Project **IEEE 802.16 Broadband Wireless Access Working Group** <<http://ieee802.org/16>>

Title **Common SYNC Symbol for OFDMA**

| Re:                          | Response to Recirculation Ballot #14c   |
| Purpose                      | To incorporate the changes here proposed into the 802.16e D5 draft.   |

Figure xxxx Common SYNC Symbol Structure (Frequency Domain)

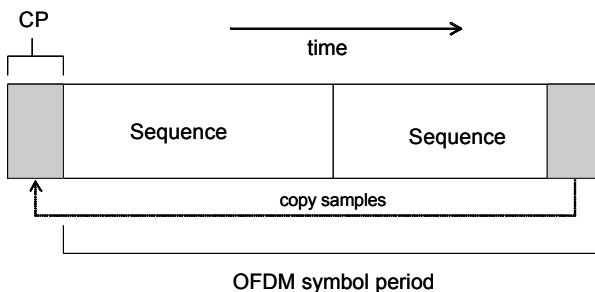
The common SYNC symbol is defined by frequency domain as shown in Figure xxxx, the time domain illustration is shown in Figure yyyy.

In every  $N_{COMMON\_CYCLE}$  (TBD) fourth downlink transmission frame,  $N_{COMMON\_FFSET}$  (TBD) symbols after the preamble the last OFDM symbol is the common SYNC symbol; it can be transmitted by the BSs in the 1024/515/128 FFT modes by antenna 0. The mapping of the common SYNC sequence to the common SYNC symbol sub-carrier is defined by using the following formula:

$$Common\_SYNC\_Carrier\_Set = N_{LEFT-FFT} + 2k - 1$$
